LUCENT TECHNOLOGIES - PROPRIETARY USE PURSUANT TO COMPANY INSTRUCTIONS			
RT13			
DETAIL CHANGE SPECIFICATION FOR 5ESS SWITCH CMP CORE BOARD MEMORY MODULE UPGRADE FEATURE			
		DWG SIZE C2	ISSUE 7
LUCENT TECHNOLOGIES INC		ED5D740-30	
		SHEET A1 OF 11

1.1.1 ED5D740-30 PROVIDES THE 5E9 CMP CORE BOARD MEMORY ENHANCEMENT FEATURE AND IS TO BE INSTALLED PRIOR TO RETROFITTING TO SOFTWARE RELEASE 5E12. THE FIELD APPLICATION OF THIS FEATURE WILL CONSIST OF UPGRADING THE EXISTING TN1368 CORE BOARD MEMORY PACKS TO A TN1800 CODE WHICH PROVIDES THE FEATURE. THE PACKS ARE LOCATED IN THE \$ COMMUNICATION MODULE 1 (CM1) MESSAGE SWITCH \$ PERIPHERAL UNIT (MSPU) AND IN THE \$ CM2 COMMUNICATION MODULE PROCESSOR UNIT (CMPU).

FIGURE 1  
PACK LAYOUT SHOWING IC'S TO BE REPLACED  
(CIRCUIT MODULES REMOVED)

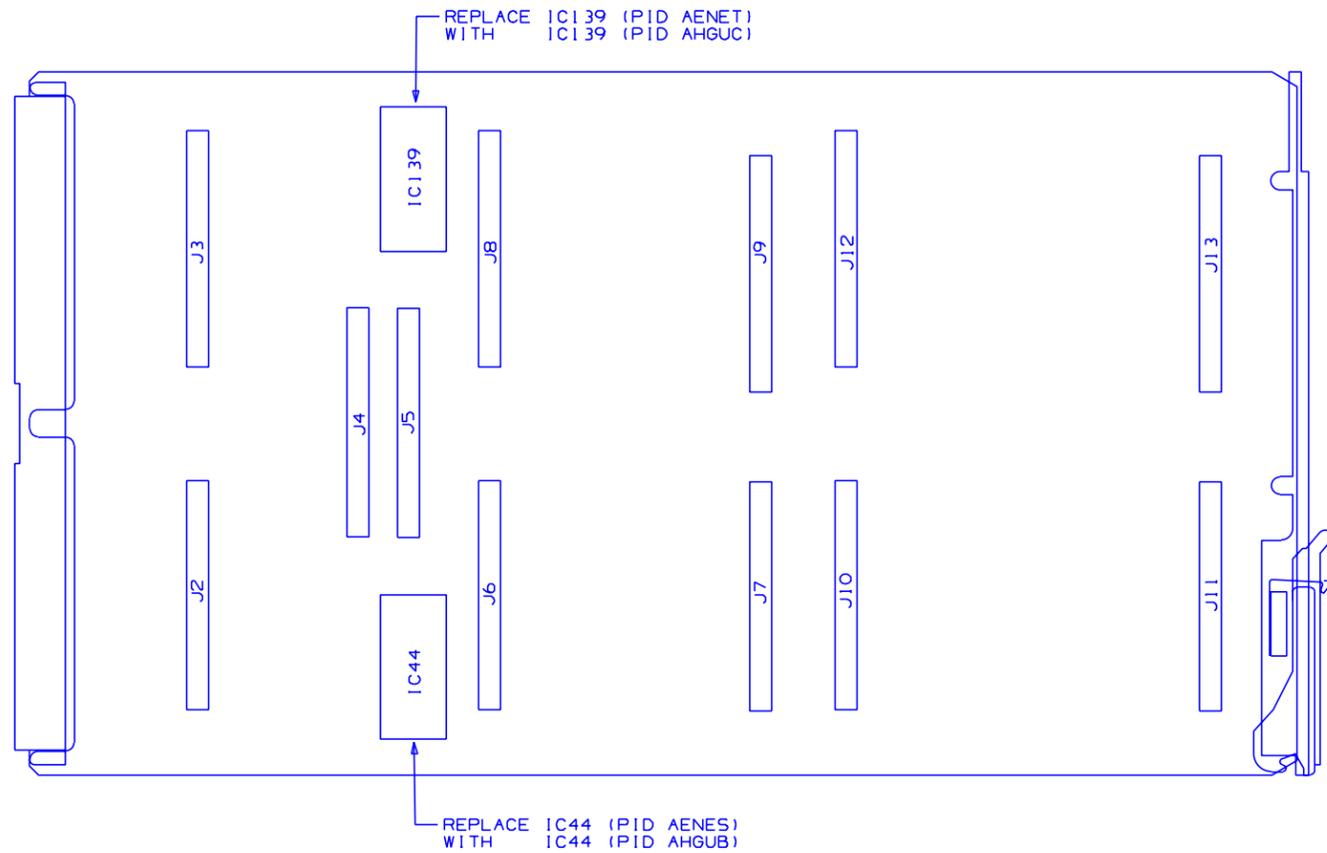
3.1.1 INSTALLATION OF ED5D740-30 WILL REQUIRE THE MODIFICATION OF EACH EQUIPPED AND SPARE TN1368 CMP CORE BOARD. THE MODIFICATION WILL CONSIST OF THE REPLACEMENT OF TWO IC(S) (IC44, IC139 - PID CODES AENES, AENET, RESP.) AND THE REMOVAL AND REPLACEMENT OF TWO CIRCUIT MODULES. SEE FIGURES 1 AND 2 FOR THE LOCATION OF THESE ITEMS FOR REPLACEMENT. A CLI UPDATE WILL ALSO BE REQUIRED AT THE TIME OF THE PACK MODIFICATION.

B. "THIS SECTION PROVIDES FOR THE REMOVAL OF TWO IC(S) ON THE MAIN BOARD (IC44,IC139). KEEP FIGURE 1 AVAILABLE FOR REFERENCE WHILE THESE STEPS ARE BEING PERFORMED".

B2. CAREFULLY RELEASE THE RETAINING CLIPS AND LIFT THE IC OUT (IF USING THE EXTRACTION TOOL), OR GENTLY LIFT EACH END OF THE IC TO SLOWLY UNPLUG IT FROM ITS CONNECTOR. REMOVE IC44 (PID CODE AENES) AND IC139 (PID CODE AENET). REFER TO FIGURE 1 FOR LOCATIONS.

C. "THIS SECTION PROVIDES FOR THE INSTALLATION OF THE TWO NEW INTEGRATED CIRCUITS REQUIRED WITH THIS FEATURE. AGAIN, KEEP FIGURE 1 AVAILABLE WHILE THESE STEPS ARE BEING PERFORMED".

C1. CAREFULLY ADD THE NEW IC44 (PID CODE AHGUB) IN THE LOCATION SHOWN IN FIGURE 1. USING THE IC INSERTION TOOL, CAREFULLY ALIGN THE TERMINALS OF THE IC UNIT WITH ITS CONNECTOR AND APPLY A STEADY PRESSURE TILL THE IC IS INSERTED AND THE CLIPS LOCK.

C2. CAREFULLY ADD THE NEW IC139 (PID CODE AHGUC) IN THE SAME MANNER INTO ITS CONNECTOR LOCATION AS SHOWN IN FIGURE 1.

FIGURE 2  
PACK LAYOUT WITH CIRCUIT MODULES

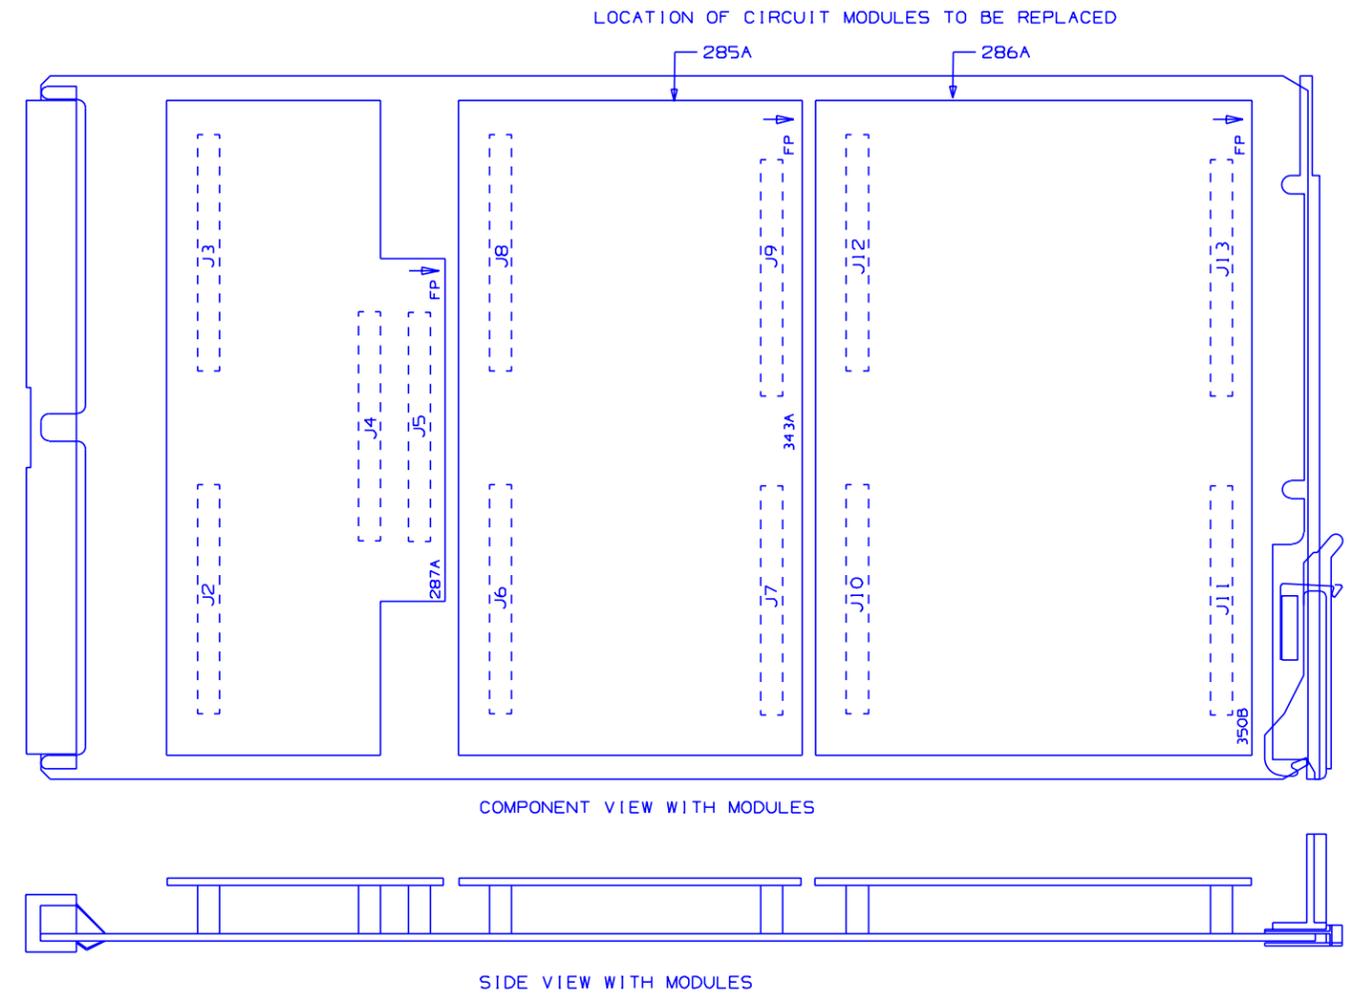
NOTE: FIGURE 1 MUST BE REFERENCED FOR LOCATIONS OF IC(S) BEING REPLACED AND FIGURE 2 FOR THE LOCATION AND CODES OF THE CIRCUIT MODULES BEING REPLACED. ALL REFERENCED FIGURES IN THE STEPS BELOW MUST BE VIEWED, AS RECOMMENDED, DURING MODIFICATION OF THE PACK.

A. THIS SECTION PROVIDES FOR REMOVAL OF CIRCUIT MODULES 285A AND 286A-286F. KEEP FIGURES 2 AND 3 AVAILABLE FOR REFERENCE WHILE THESE STEPS ARE BEING PERFORMED

FIGURE 3  
CIRCUIT MODULE REMOVER TOOL POSITIONS

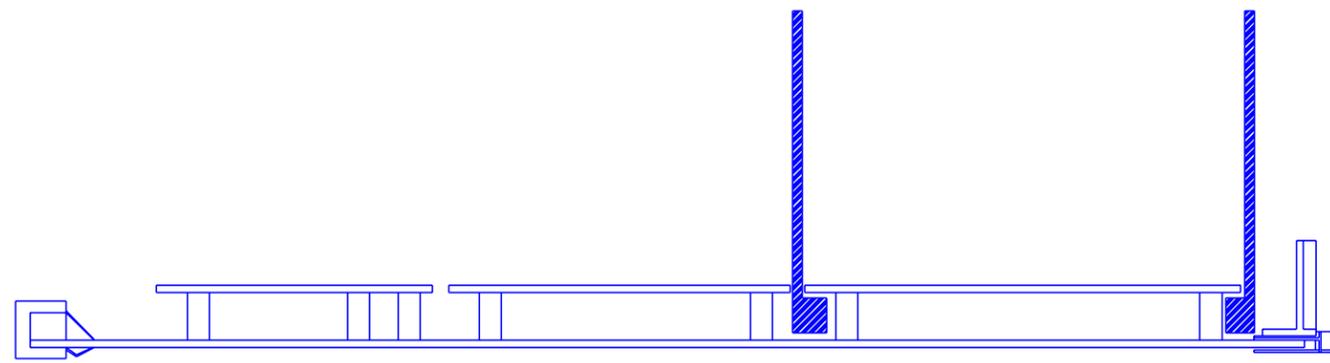
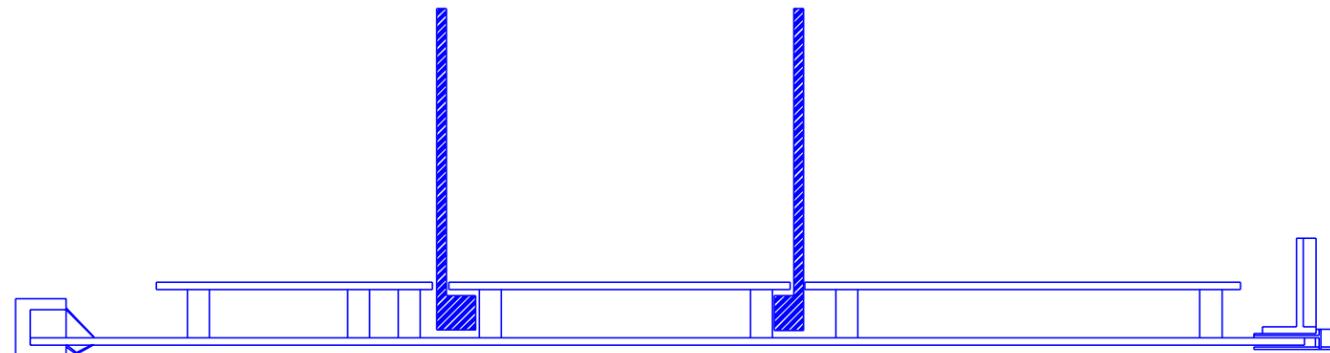
POSITION THE CIRCUIT MODULE REMOVAL TOOL UNDER THE MODULE SHOWN IN FIGURE 3 FOR THE REMOVAL OF THE 286A-286F MODULE.

A6. NEXT, POSITION THE REMOVAL TOOL IN THE POSITION SHOWN IN FIGURE 3 FOR THE REMOVAL OF THE 285A MODULE.

A7. PERFORM STEPS A2 THRU A5 FOR THE 285A MODULE. REMEMBER TO AVOID FLEXING THE BOARD.

FIGURE 4  
CIRCUIT MODULE CONNECTOR POSITIONS ON MAIN BOARD

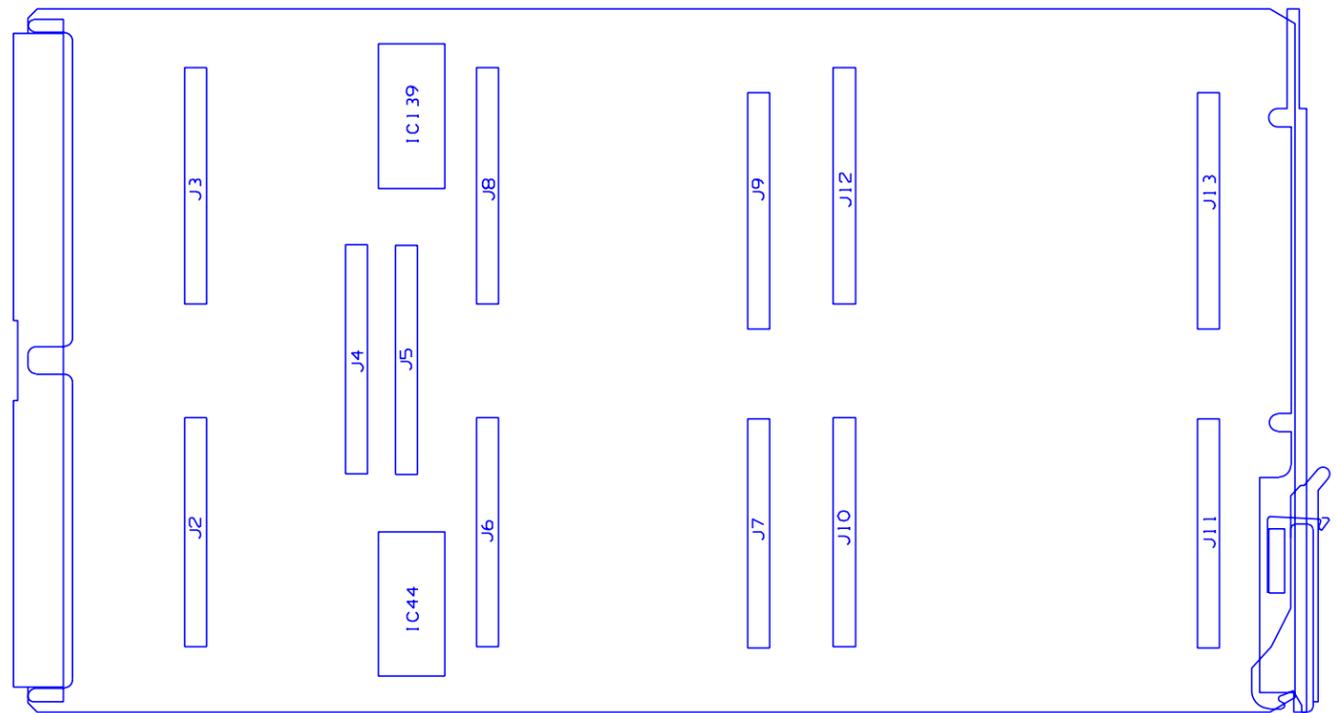
D2. LOCATE THE FOUR (4) CONNECTORS ASSOCIATED WITH THE 343A MODULE (FIGURE 4) AND CAREFULLY PLACE THE MODULE ON THEM. MAKE SURE THE MODULE ORIENTATION MARK (FIGURE 5) IS POINTING TOWARD THE FRONT (LATCH-END) OF THE PACK. BEFORE INSERTING THE MODULE, MAKE SURE "ALL" HEADER PINS LINE UP WITH THE CONNECTOR HOLES. IT IS VERY EASY TO BE ONE ROW OFF.

FIGURE 5  
CIRCUIT MODULE ORIENTATION

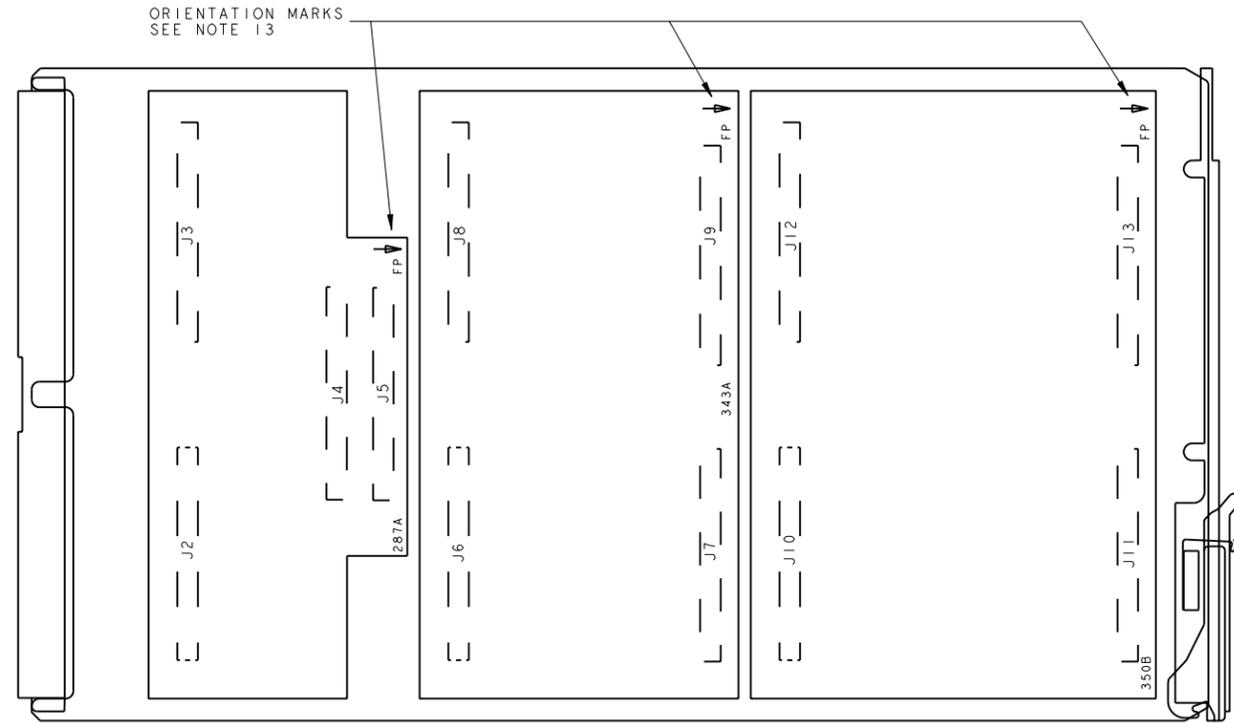
D1. FROM FIGURE 5, IT SHOULD BE NOTED THAT THE 343A MODULE WILL BE LOCATED IN THE CENTER OF THE BOARD AND THE 350B MODULE ON THE RIGHT. INSTALL THE 343A IN THE CENTER FIRST.

FIGURE 10  
RCV FIELD LAYOUT FOR CLI CHANGE

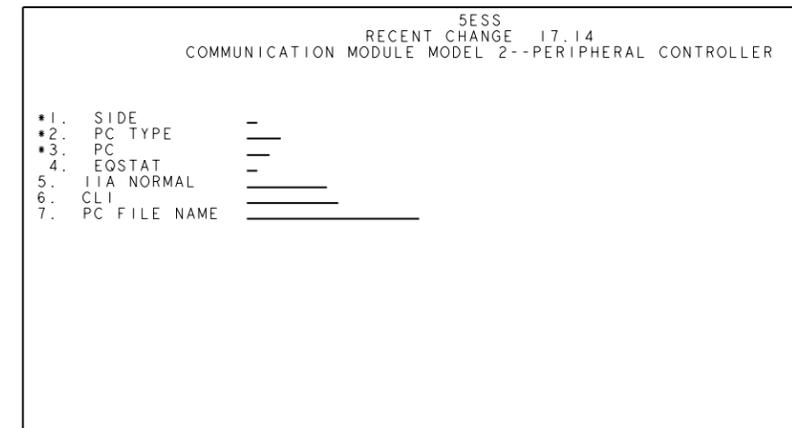
3.3.3 UPDATE THE CLI VALUE FOR THE OUT-OF-SERVICE MSGS/CMP. REFER TO FIGURE 10 FOR AN EXAMPLE OF THE RECENT CHANGE VIEWS THAT WILL

NOTE: THE VIEWS SHOWN IN FIGURE 10 ARE TO BE USED AS AN "EXAMPLE" ONLY. THEY MAY OR MAY NOT BE WHAT IS ACTUALLY VIEWED AT THIS TIME

- E. CONTINUE BY UPDATING THE PROPER FIELD FOR THE CM EQUIPPED:
  - \$FOR VIEW 17.2 (CM1) UPDATE FIELD 7 FROM A 0 TO 1.\$
  - \$FOR VIEW 17.14 (CM2) UPDATE FIELD 6 FROM A 0 TO 1.
